UNITED STATES PATENT AND TRADEMARK OFFICE

APPLICATION NO.	FILING DATE	FIRST NAMED INVENTOR	ATTORNEY DOCKET NO.	CONFIRMATION NO.
10/687,921	10/20/2003	Yao-Ching Su	025789-00010	8340
4372	7590	02/22/2008		
ARENT FOX LLP 1050 CONNECTICUT AVENUE, N.W. SUITE 400 WASHINGTON, DC 20036			EXAMINER BODDIE, WILLIAM	
			ART UNIT 2629	PAPER NUMBER
			NOTIFICATION DATE 02/22/2008	DELIVERY MODE ELECTRONIC

Office Action Summary	Application No.	Applicant(s)	
	10/687,921	SU ET AL.	
	Examiner	Art Unit	
	William L. Boddie	2629

DETAILED ACTION

FIG. 8

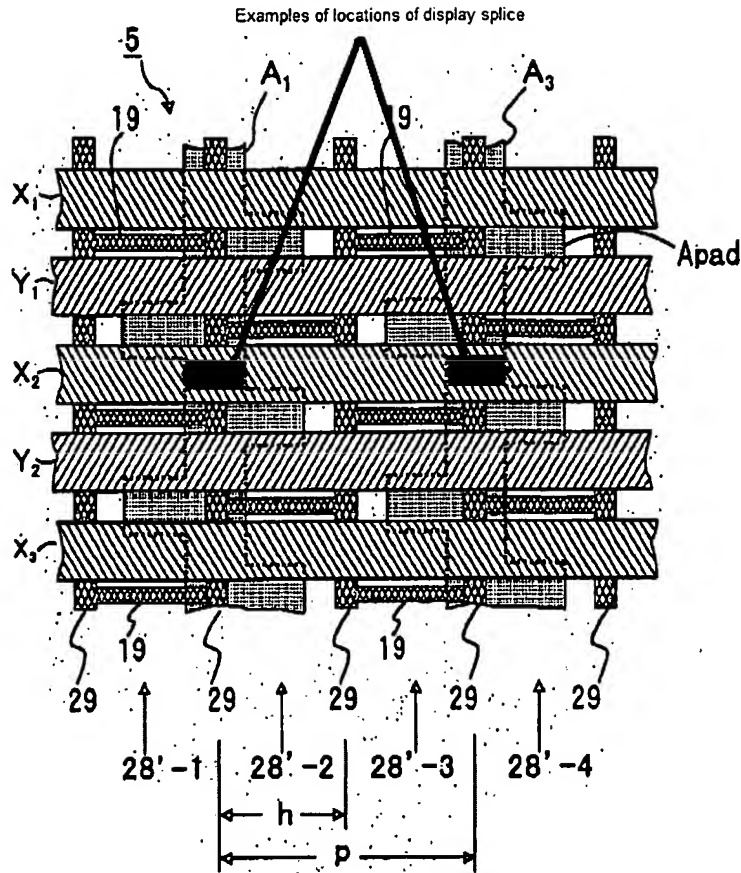
Kosaka does not expressly disclose that the gap is less than 40% of the cell length.

However, based on figure 12 it is clear that Kosaka intended that the alternating protrusions of the data electrodes continue from one half of the panel to the other. With this in mind, we turn to figure 8, where when the data electrodes are split it should be clear that there would be a gap between the row ribs, 19, and the data electrode that is less than 40% of the cell length. See the below annotated figure for further explanation.

Therefore it would have been obvious to one of ordinary skill in the art to make the display splice in a manner to ensure that the gap between a rib and data electrode is minimized to ensure proper discharge of the last pixel that the data electrode is present in. Thus the decision to design the plasma panel so as achieve a gap of less than 40% is seen as an optimum range that would have been obvious to one of ordinary skill in the art at the time of the invention.
